Pukenui Solar Farm

Section 127 Application to Vary Resource Consent Conditions

WWLA0995 | Rev. 1

15 August 2024

FIGURE 1a: The Proposal

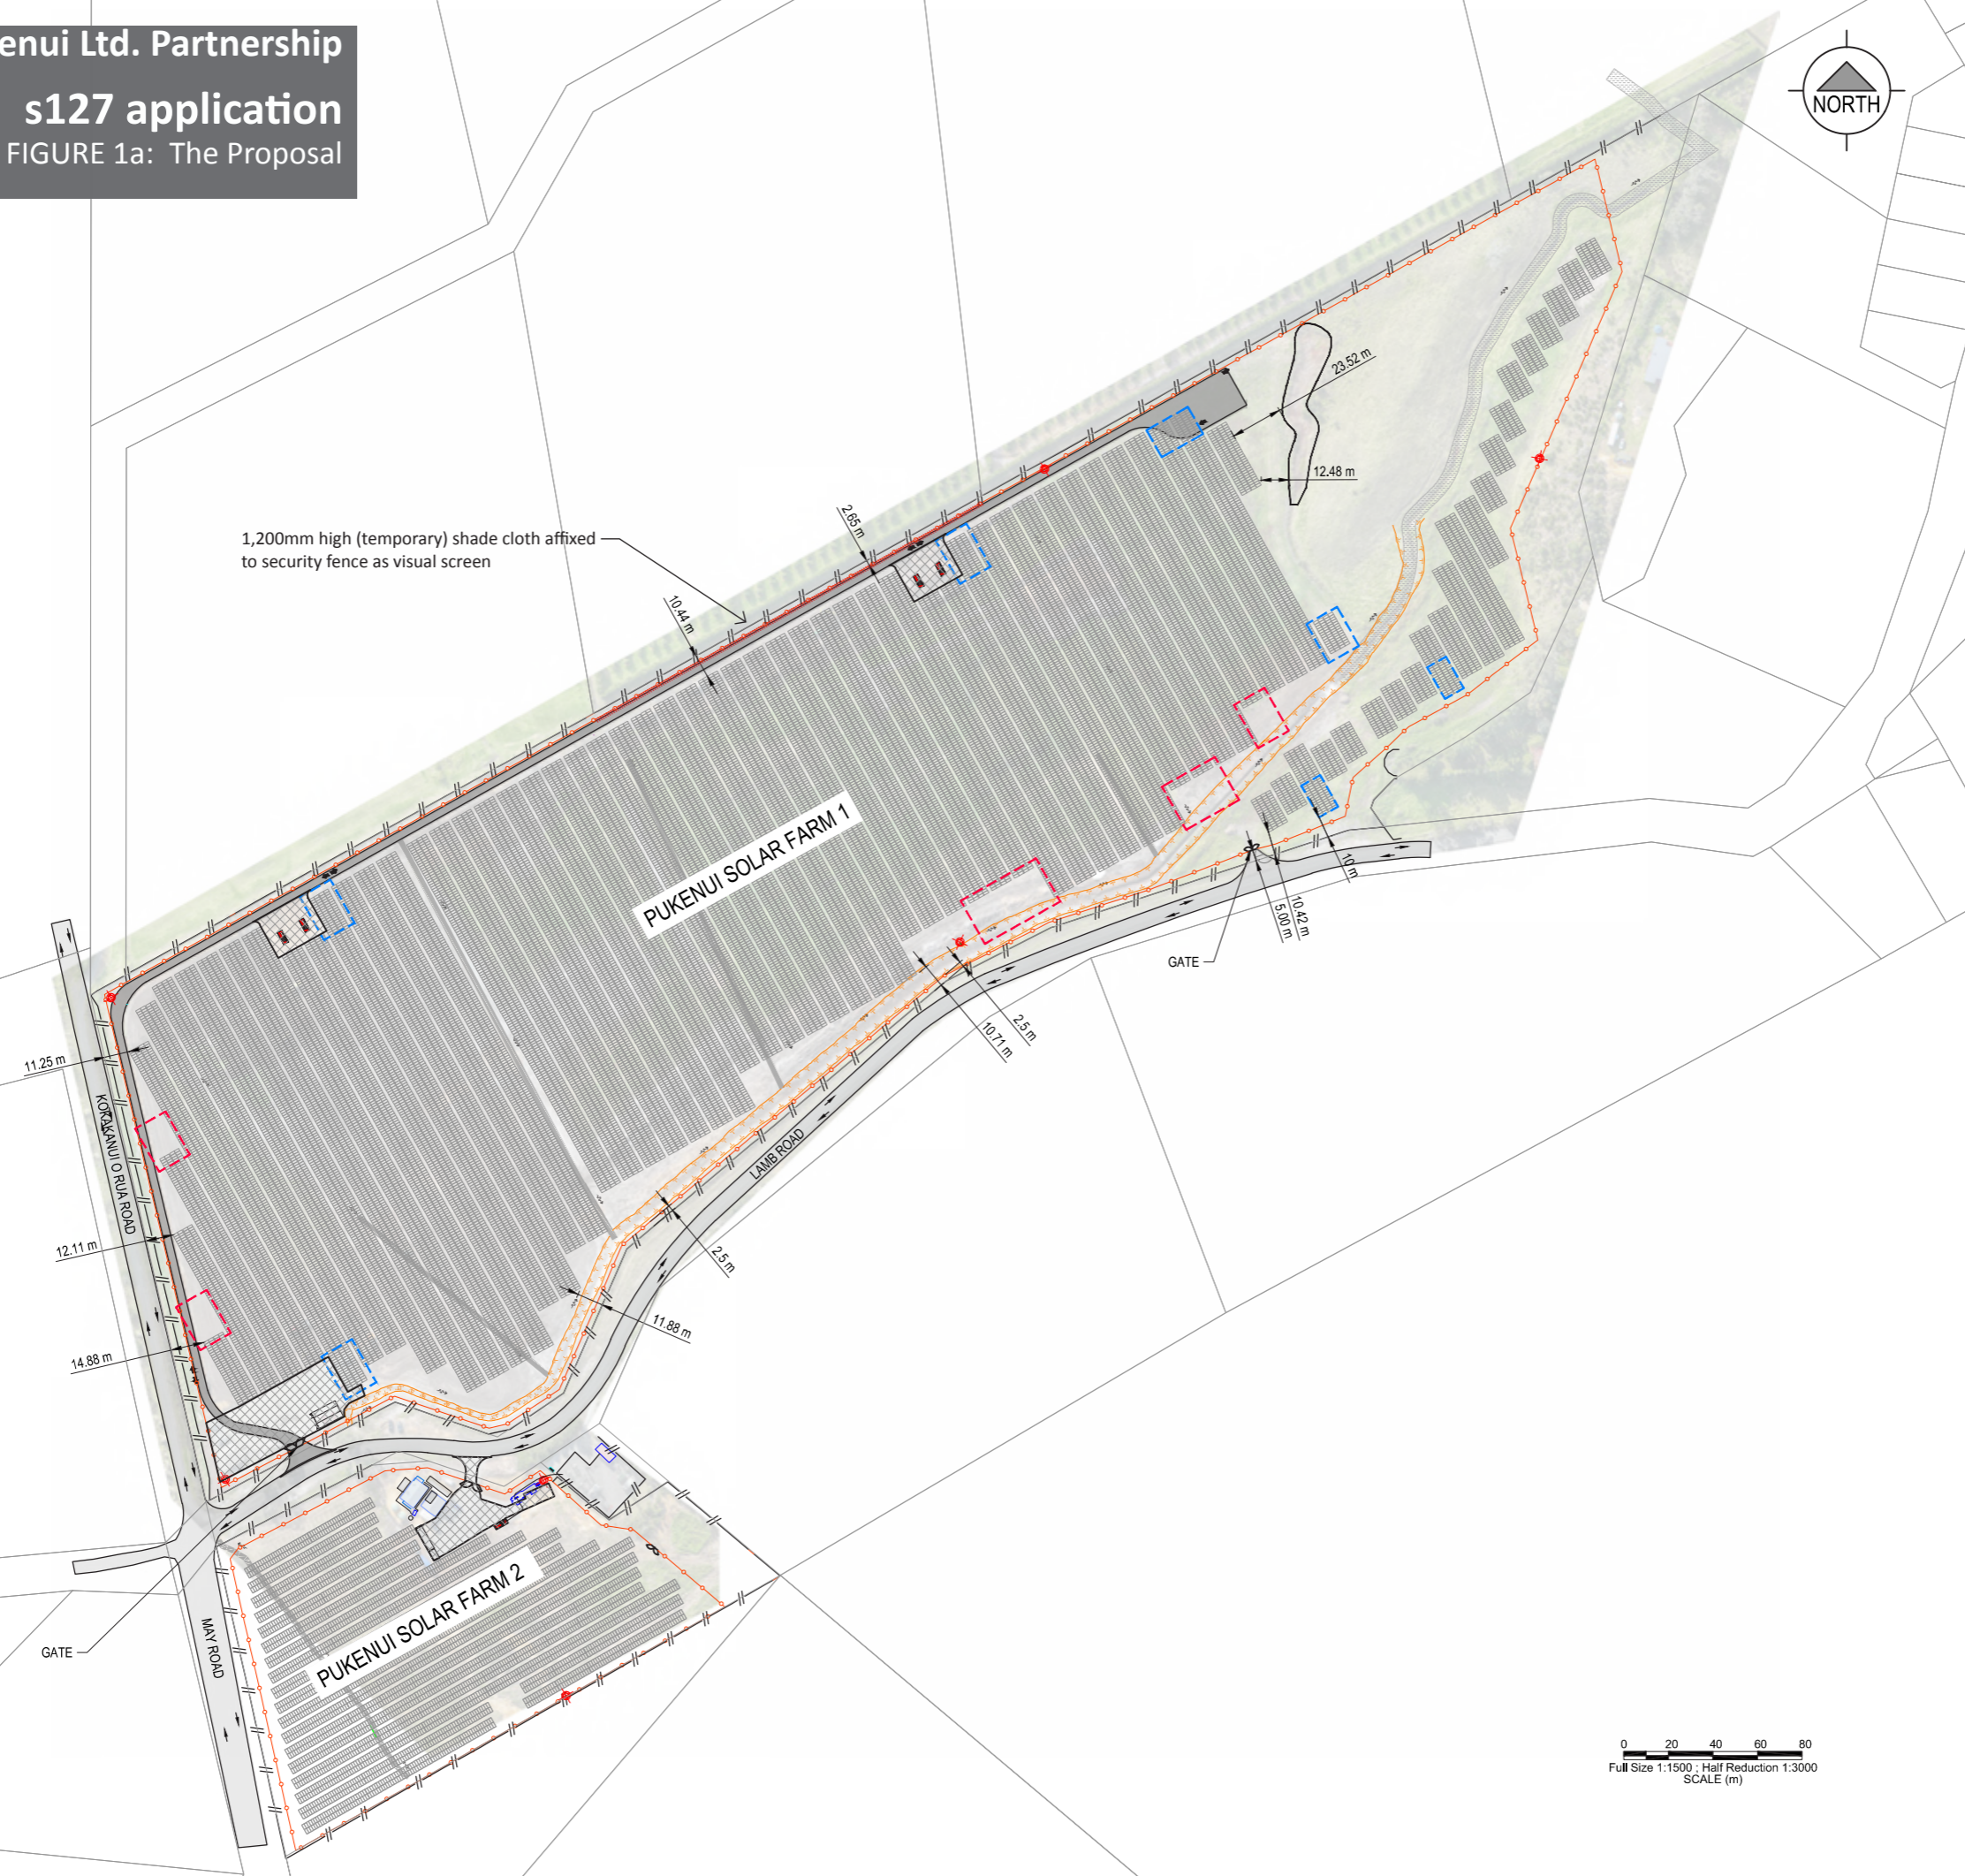
In addition, with a view to providing some immediate screening, a temporary shade cloth screen, 1.2m in height, will be erected along that portion of the Site security fence where direct views are possible from the dwelling (refer to [Figure 1a](#)).

On the southern boundary, the proposed 2.5m wide screen planting strip will allow for three rows of planting (refer to [Figure 1a](#)). The plants within these three rows will be 'staggered' such that they are offset so that they will grow to provide a dense and visually impermeable screen.

DRAWING No.: **PUK-L-1011-GA-012**

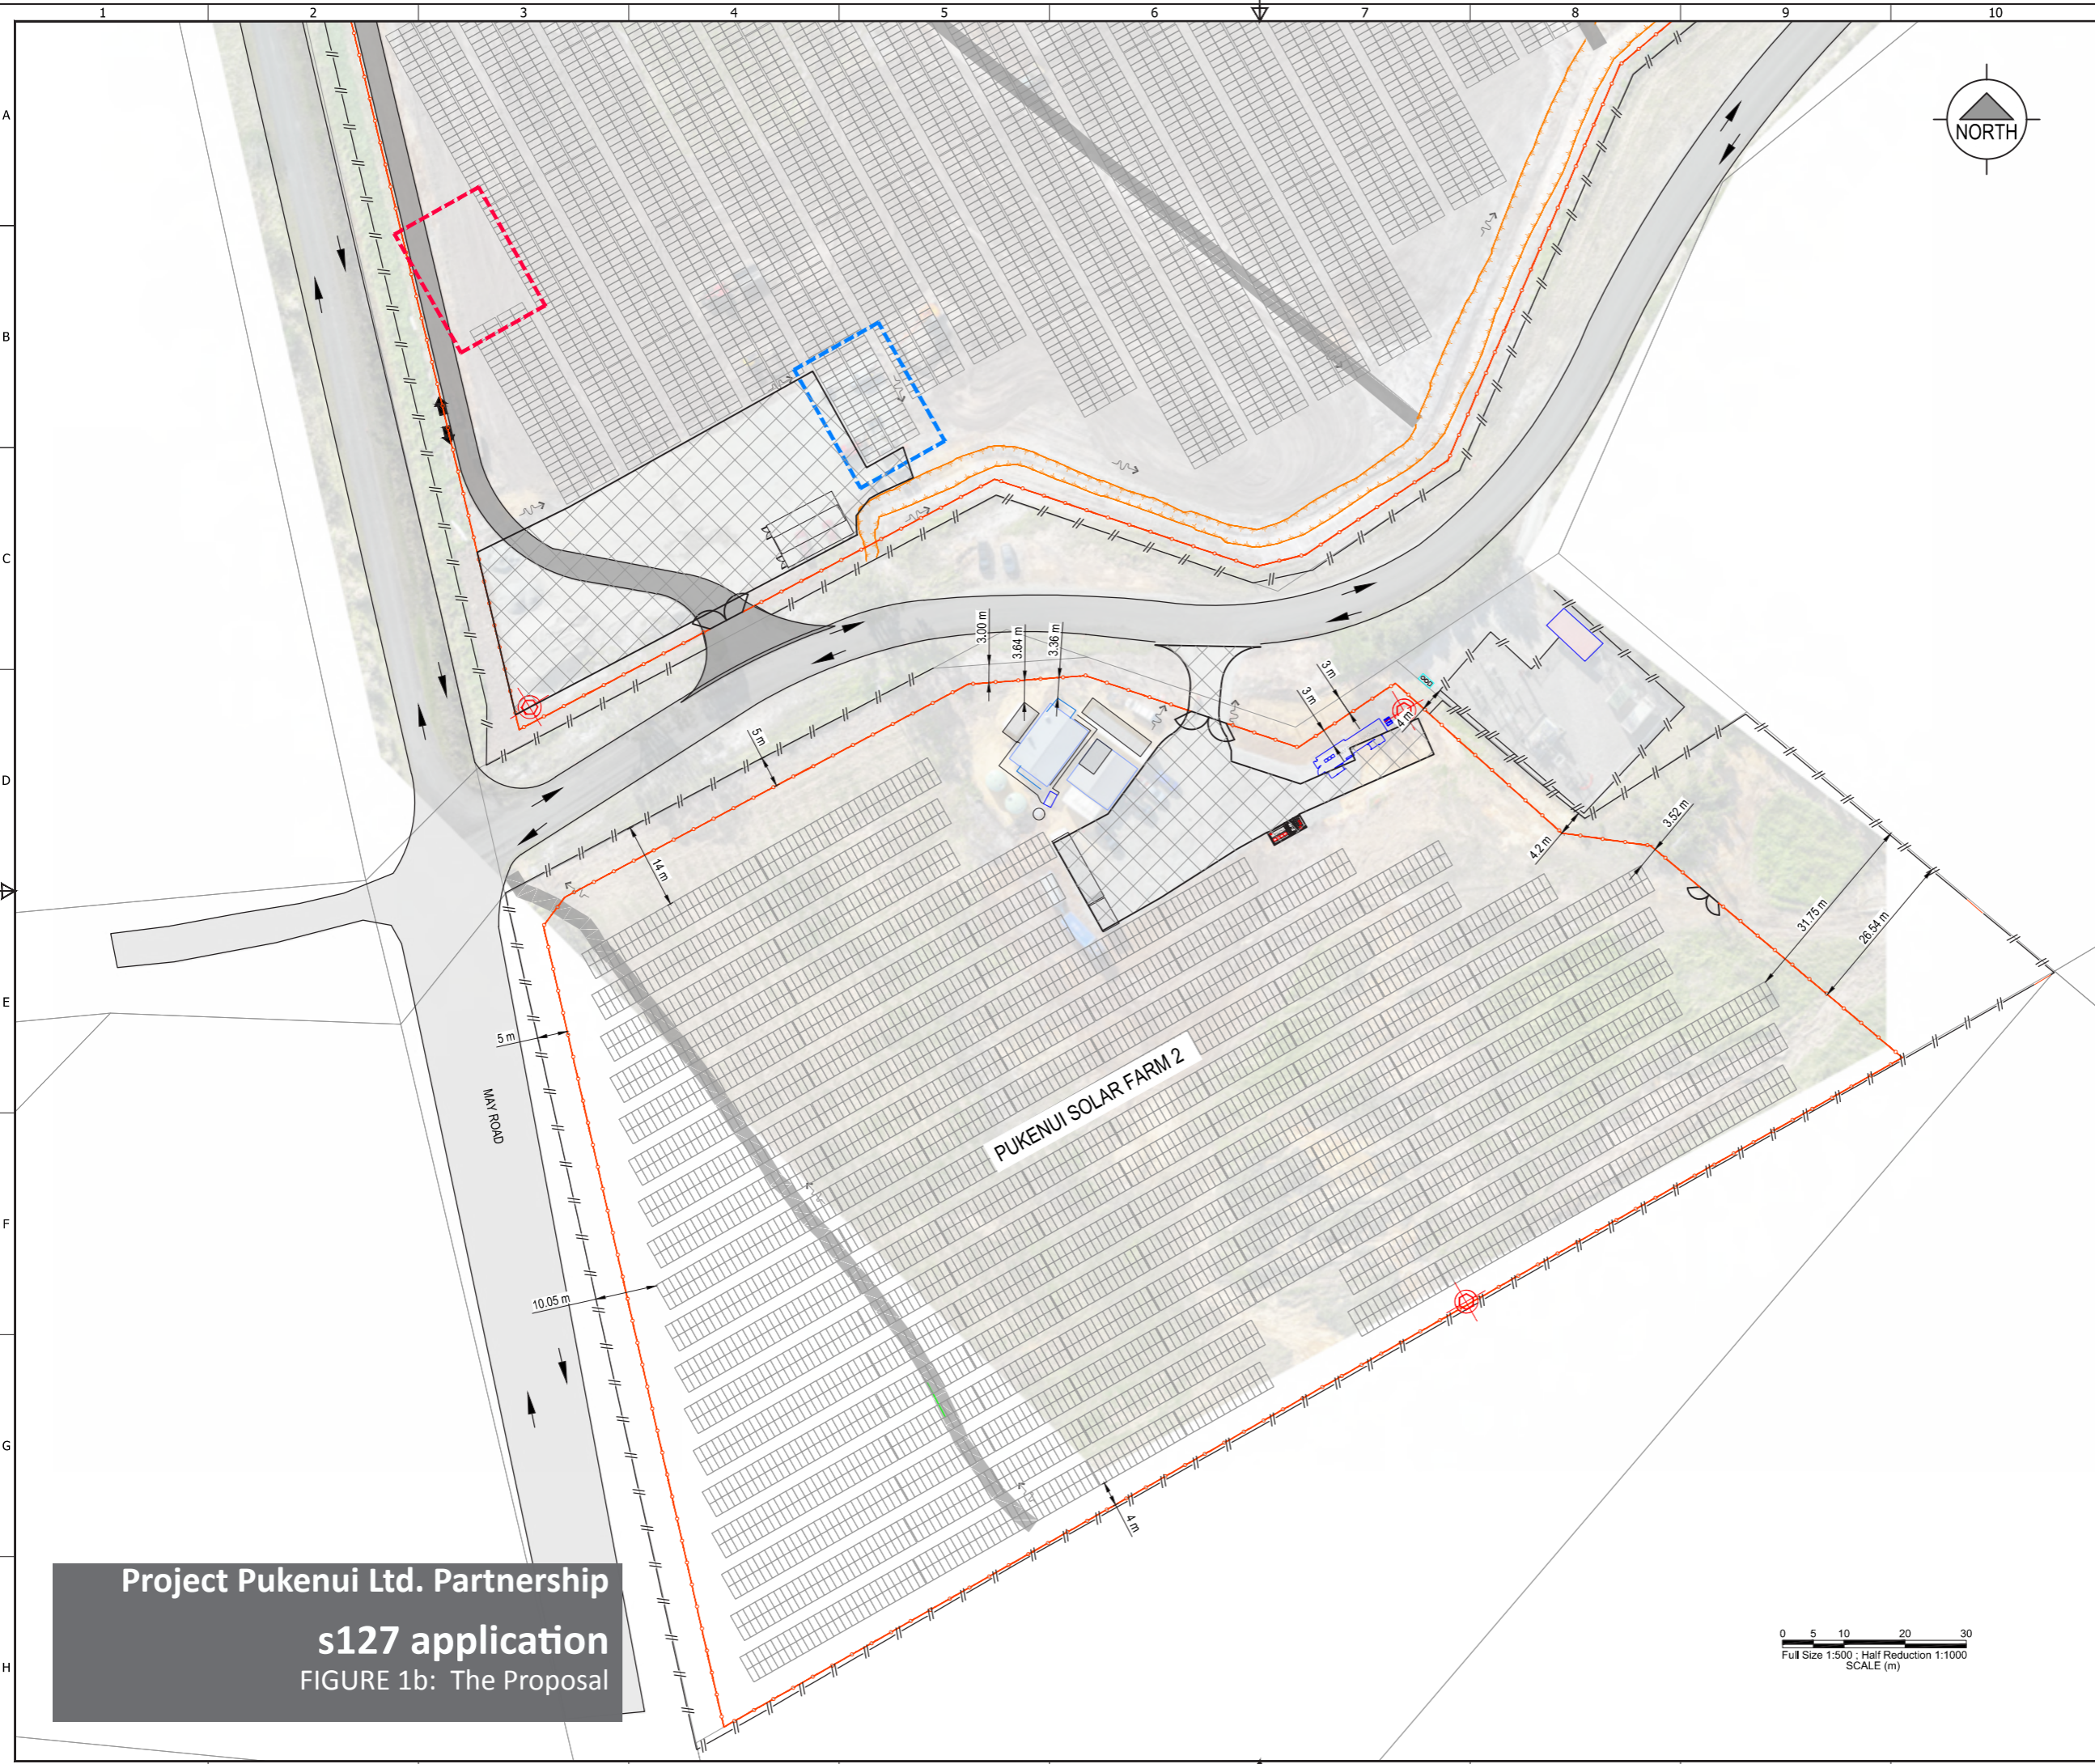
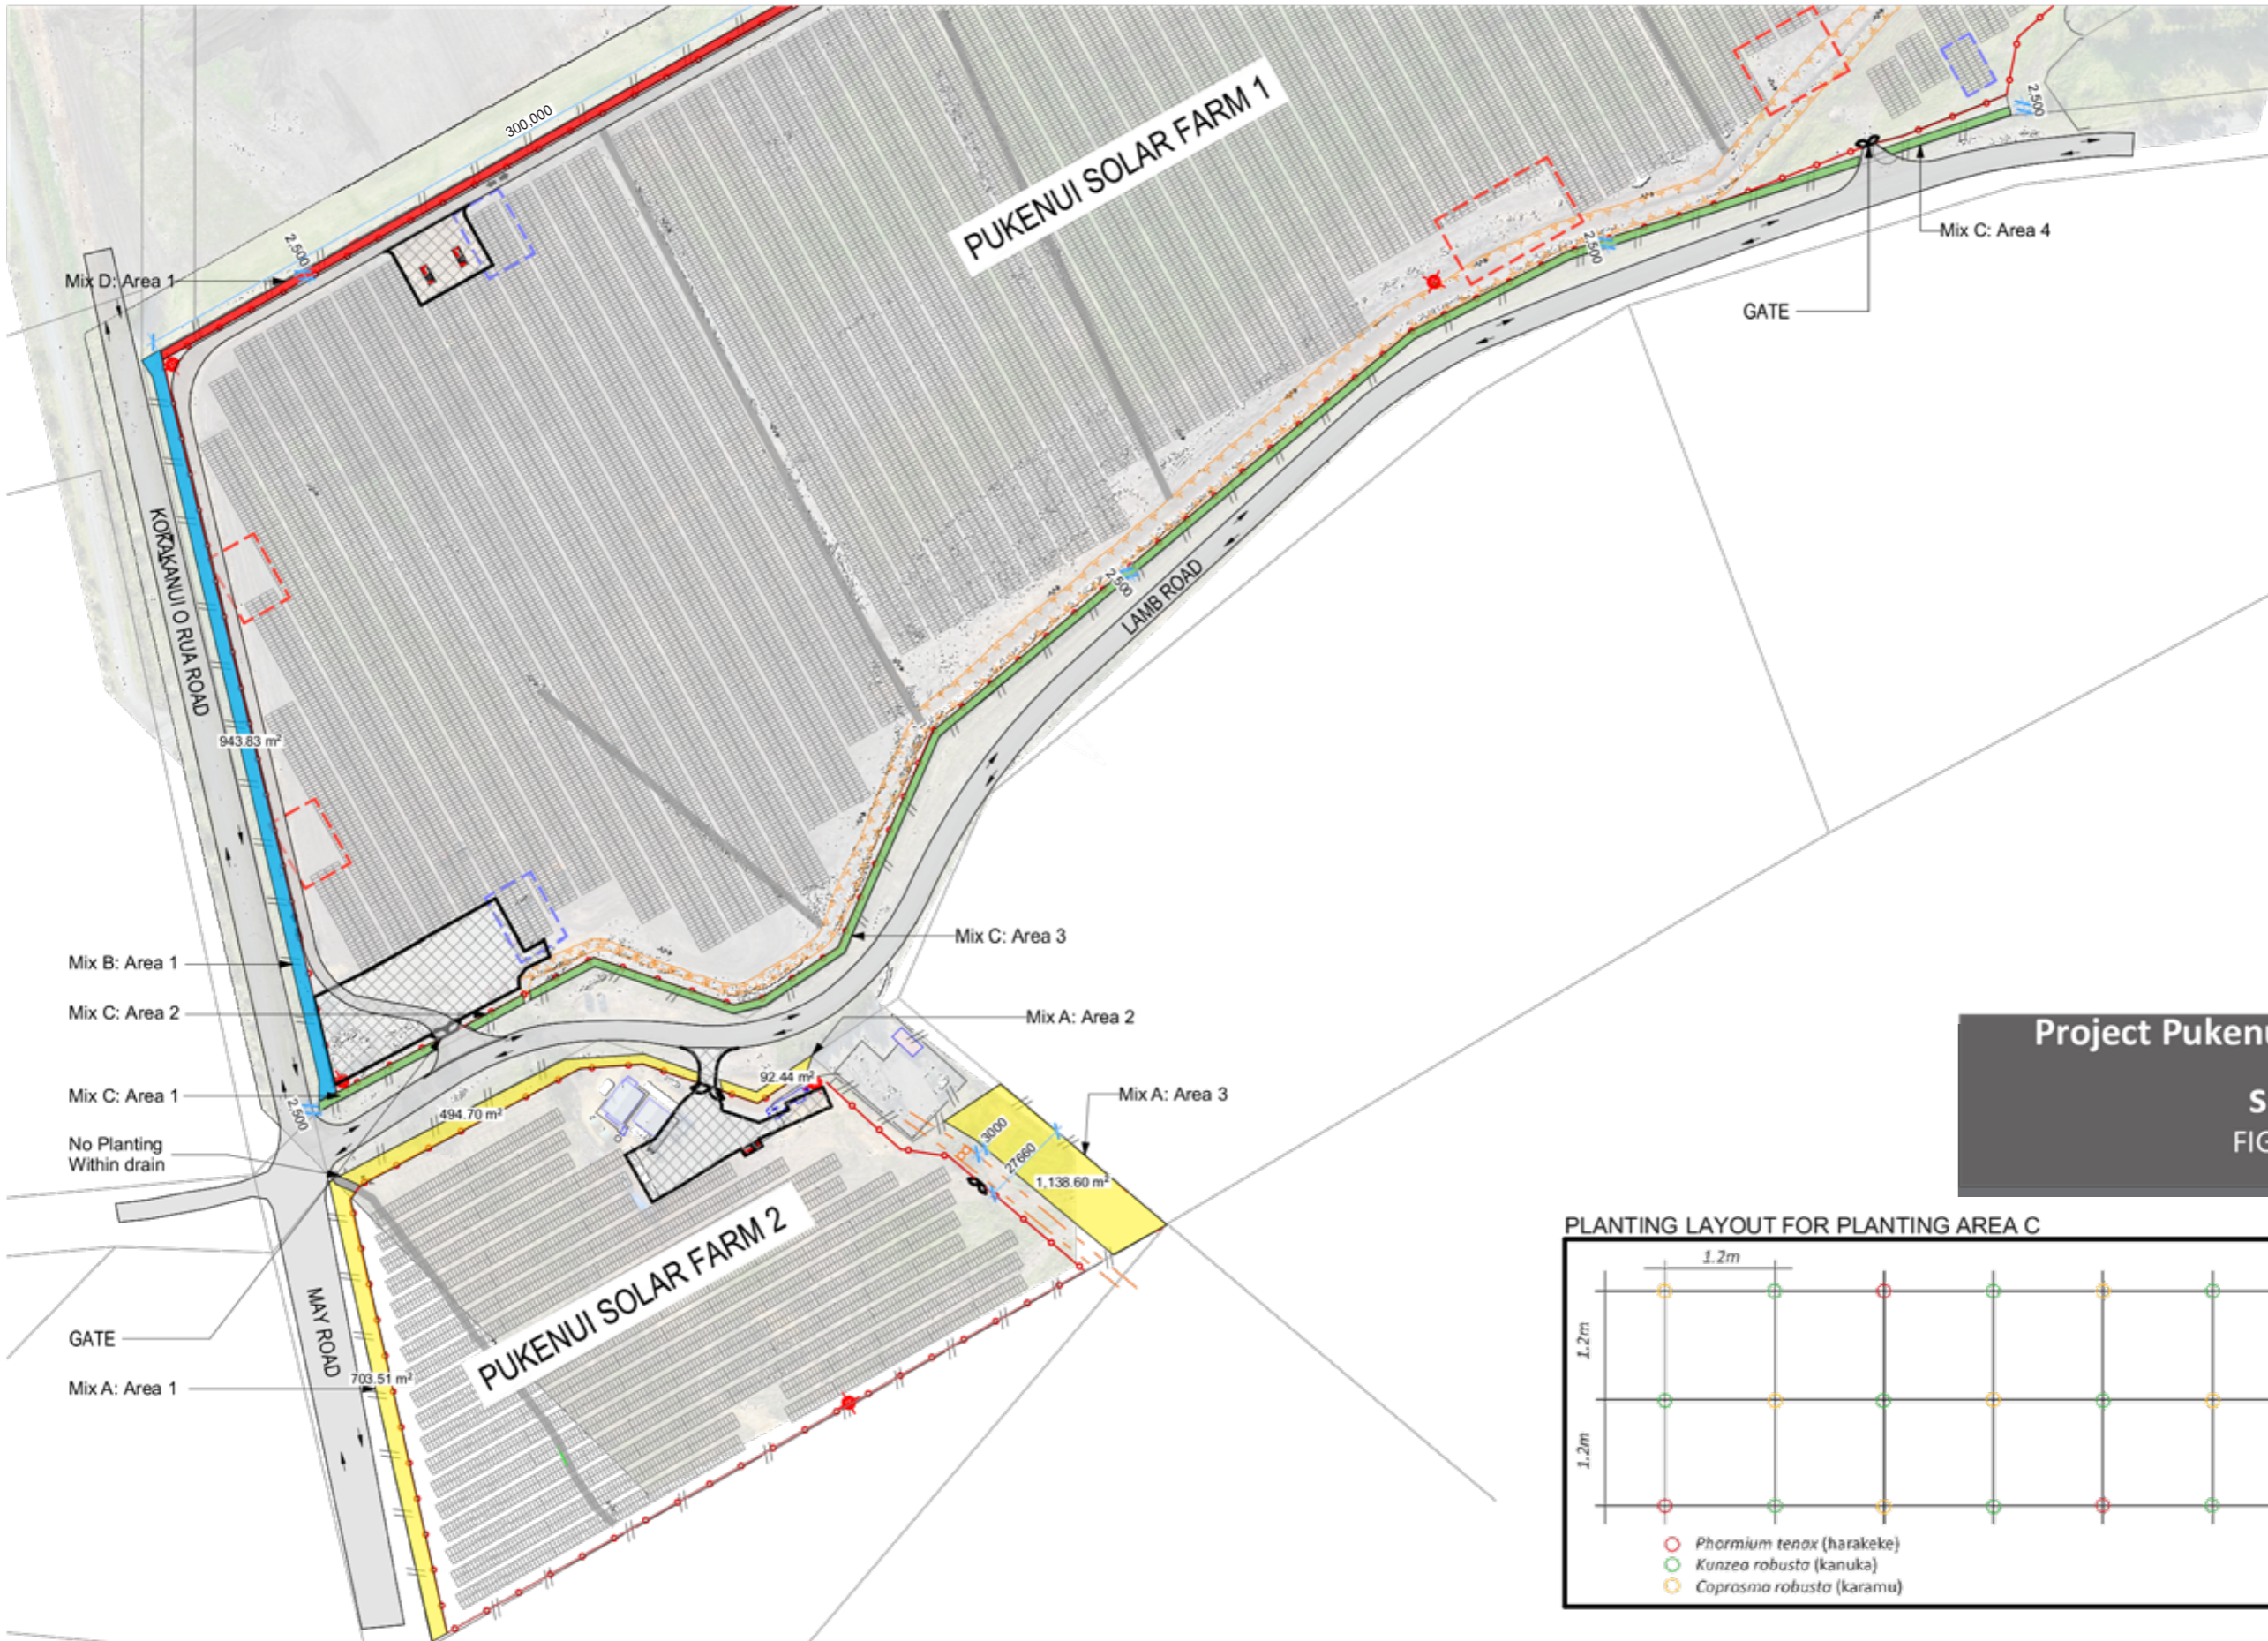
1. The activity shall be carried out in accordance with the approved plans prepared by Pukenui-2 Solar Farm, Revision ~~B C~~ dated ~~25/10/2023~~ 11/07/2024 drawing number ~~PUK-L-1011-GA-012J00795-PK-0-DWG-G003-01PUK-2~~, and attached to this consent with the Council's "Approved Stamp" affixed to it.
